SUBJECT: **Invitation for Bid #11-2084-OV
17th Street West from Amberwynd Circle (West) to Emerson Point Trail
Snead Island, (Manatee County), FL (Project #412569-1-58-01)**

ADDENDUM #1

RE: Addendum 1
Emerson Point Trail – Manatee County, Florida
CSDG Project # 17156.43

TYPICAL SECTION
STA 14+50 TO STA 15+65
STA 33+86.97 TO STA 34+11.45
SCALE: N.T.S.

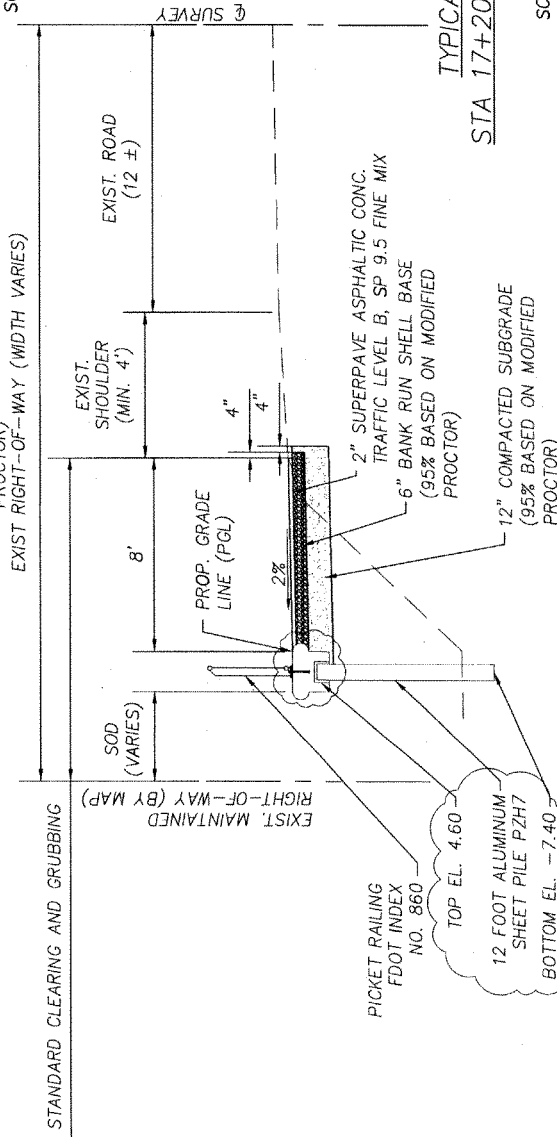
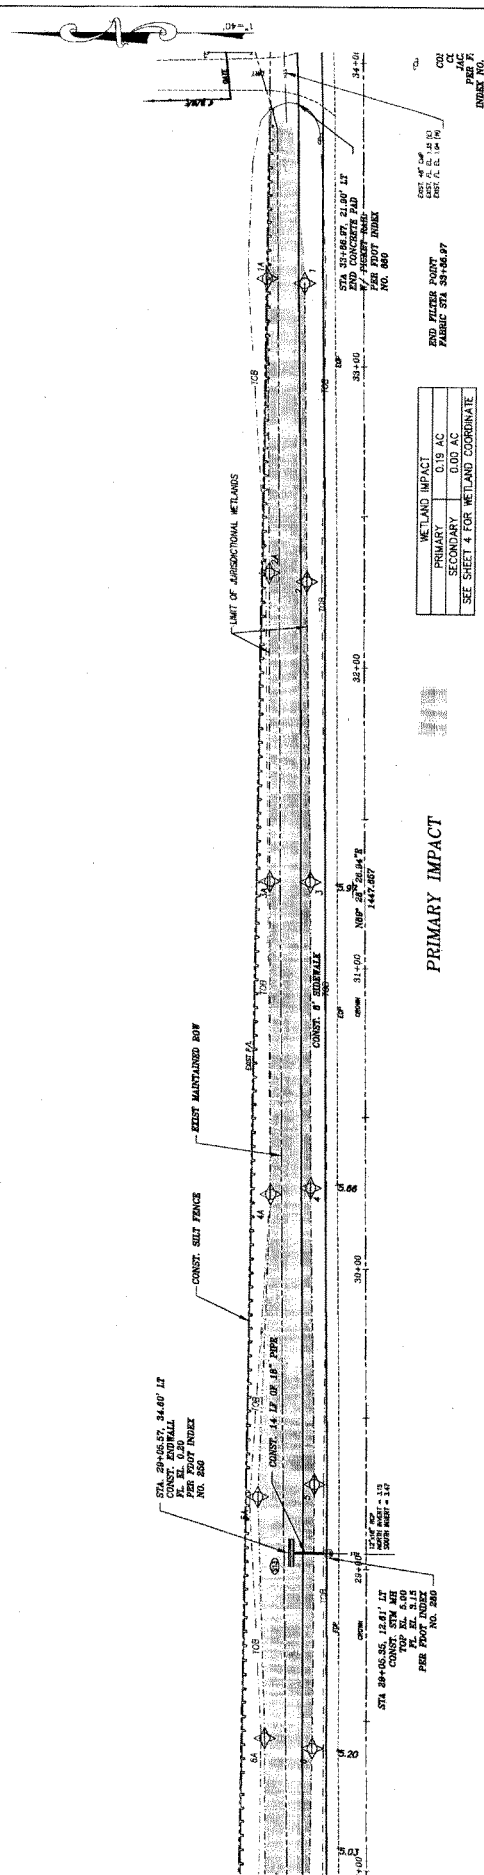
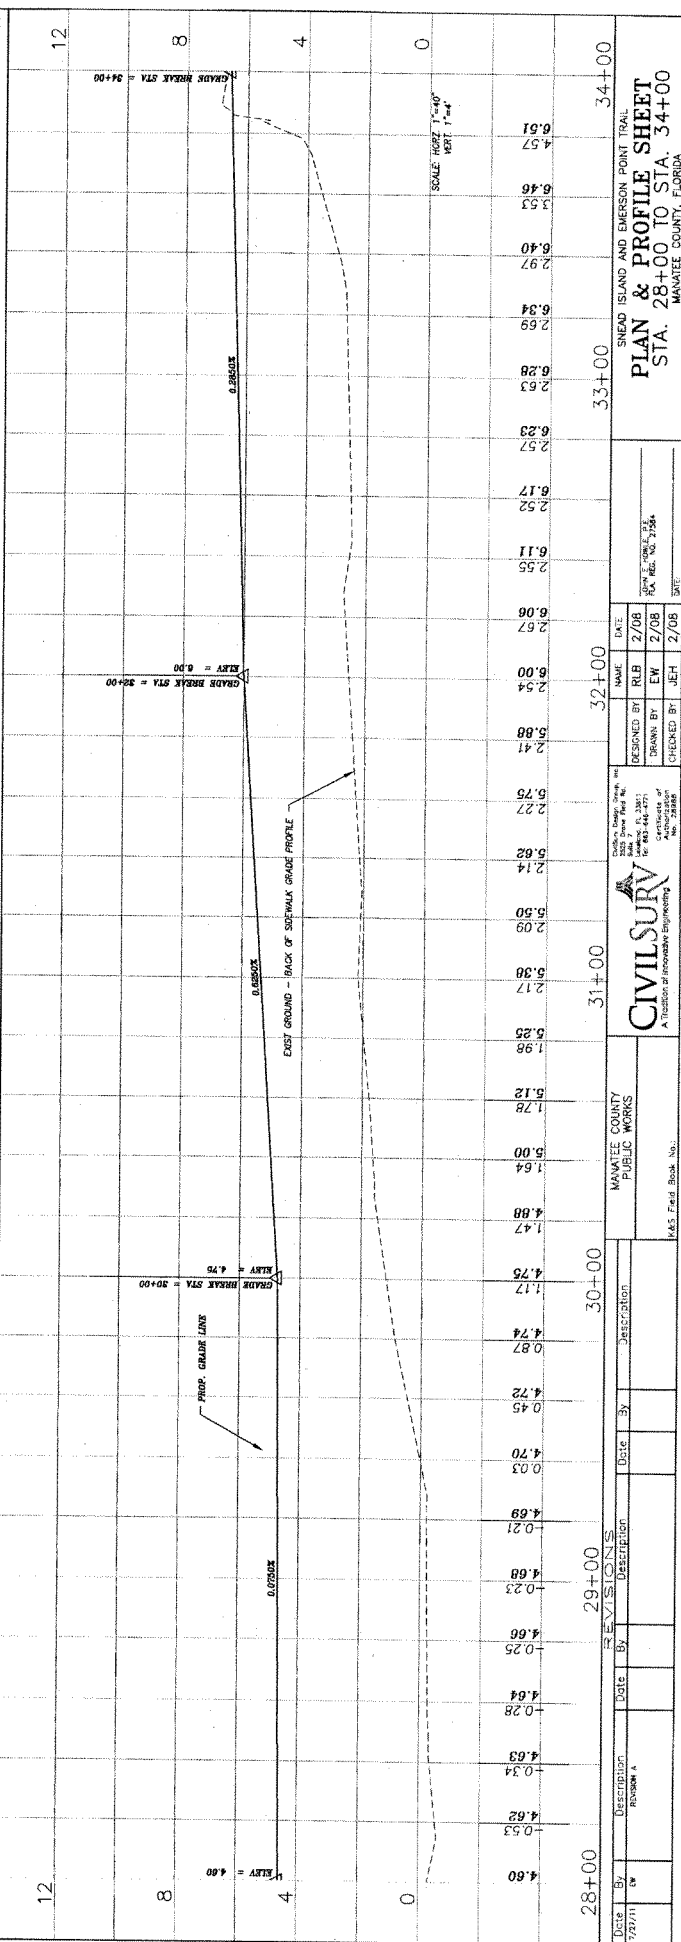
Question 4 More information is needed to construct the sheet pile wall, material type, elevations, and sheet length.

Question 5 Gravity wall elevation is needed. Will the wall follow sidewalk grade?

Question 6 Will the sheet pile have a concrete or aluminum cap?

Question 7 A detail is needed for the connection between the gravity wall and sheet pile wall.

Response 4 *From sheet 16, the sheet pile type is to be PZH-7 with an aluminum cap. Top of sheet pile will be at an elevation of 4.60 with a sheet length of 12 feet.*

Response 5 *Gravity wall elevation will follow the sidewalk grade.*

Response 6 *Sheet pile will have an aluminum cap.*

Response 7 *Detail for connection between gravity wall and sheet pile have been included on sheet 16 of the plans.*

TOP EL. 4.60
12 FOOT ALUMINUM
SHEET PILE P2H7
BOTTOM EL. -7.40
